Riverfront Phase IIB Fort Wayne, IN

ADDENDUM #1

October 7, 2024

ADDENDUM NO. 1

16 SEPT 2024 S311 SCALE: 3/4" = 1'-0" LC JOB NO.: 1818

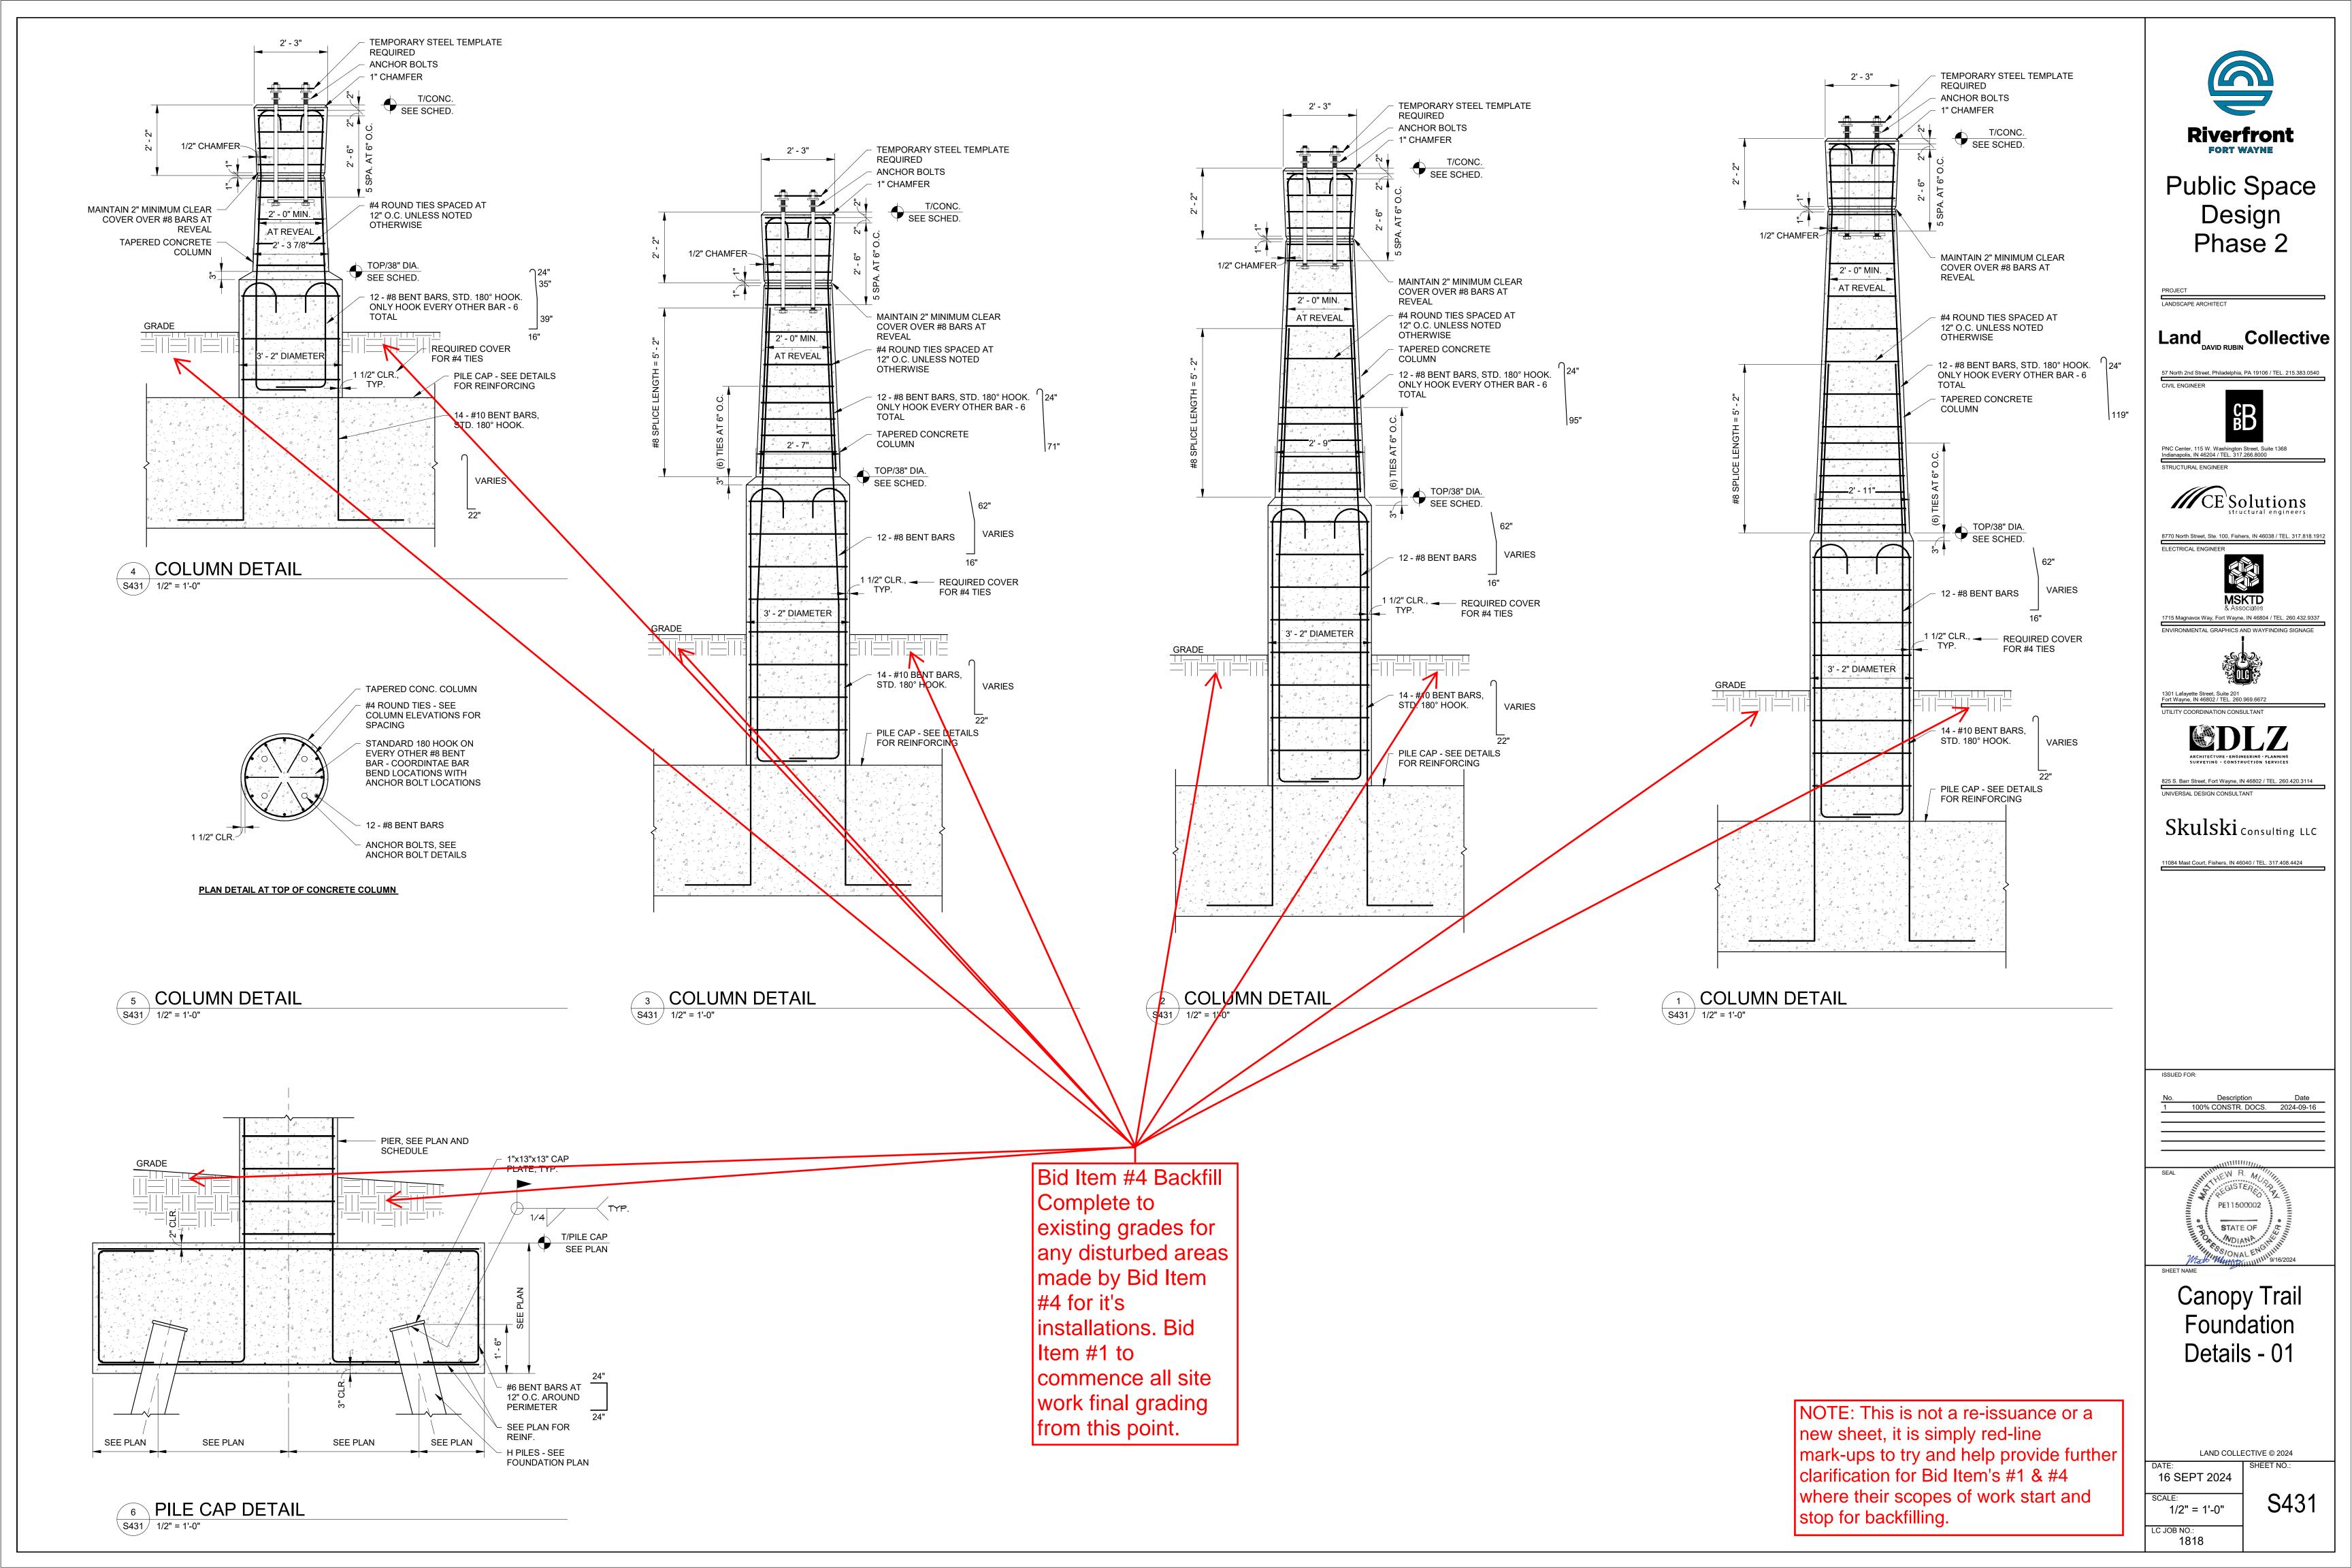
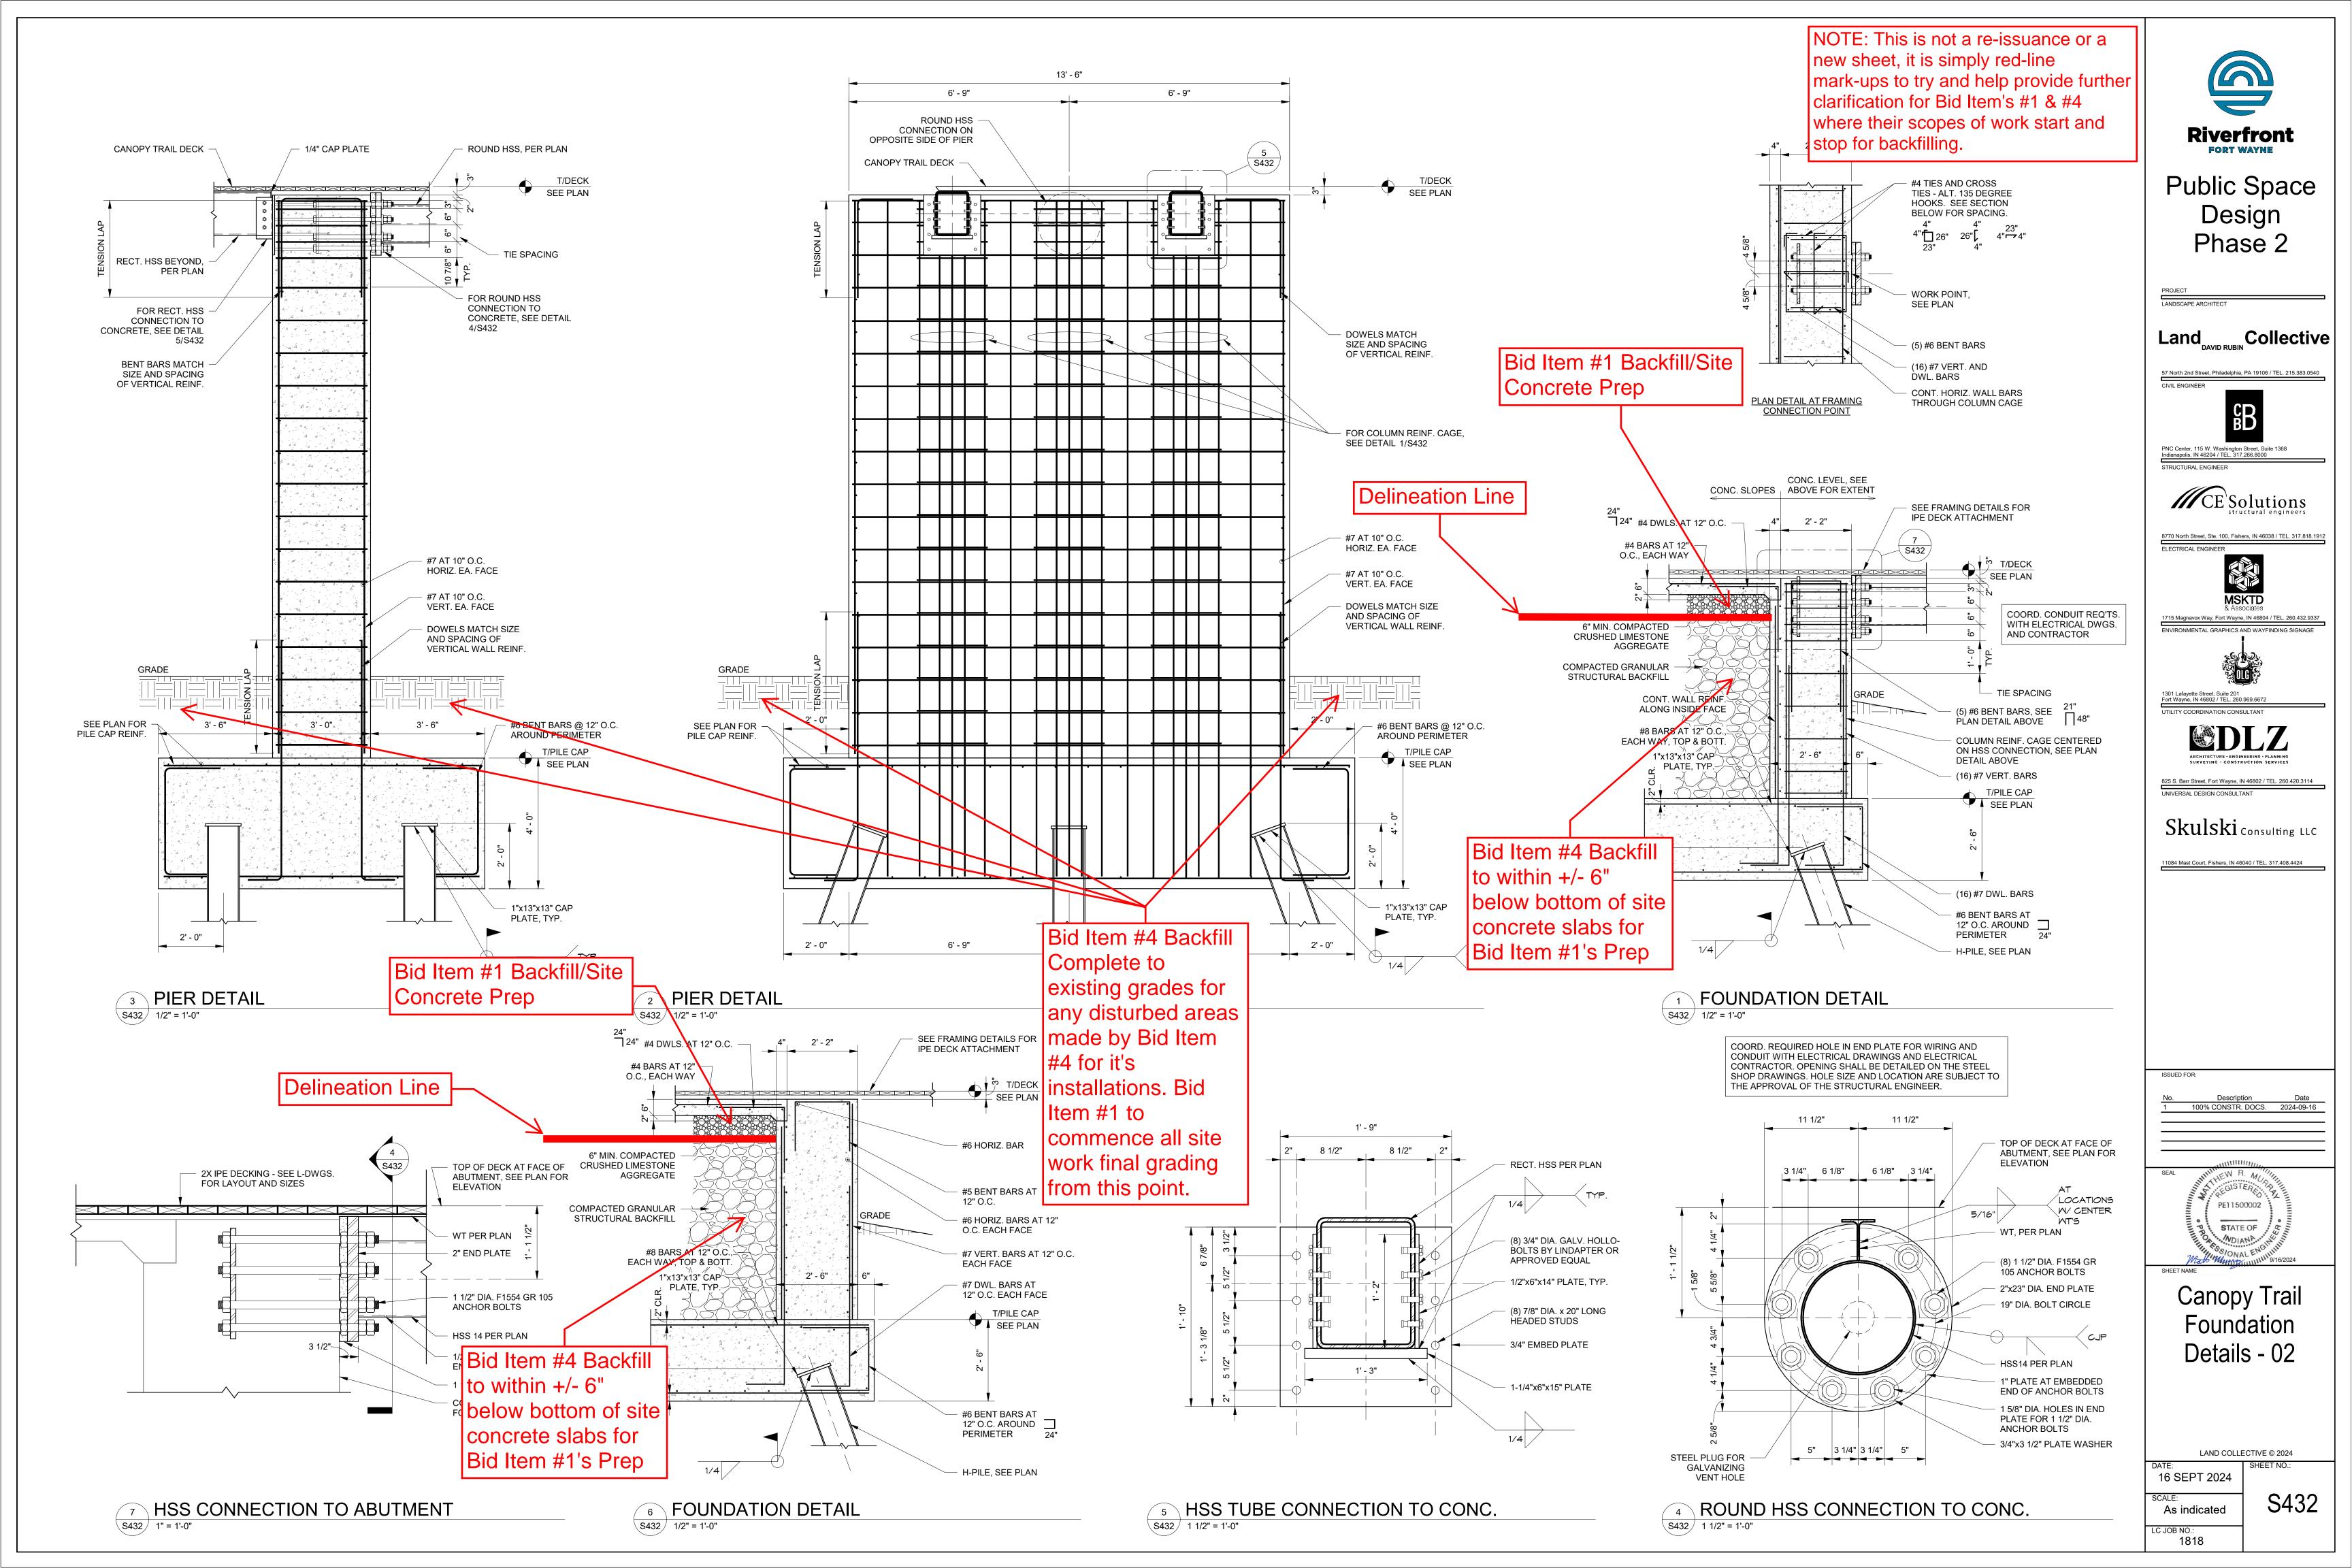
NOTE: This is not a re-issuance or a new sheet, it is simply red-line mark-ups to try and help provide further clarification for Bid Item's #1 & #4 where their scopes of work start and stop for backfilling.
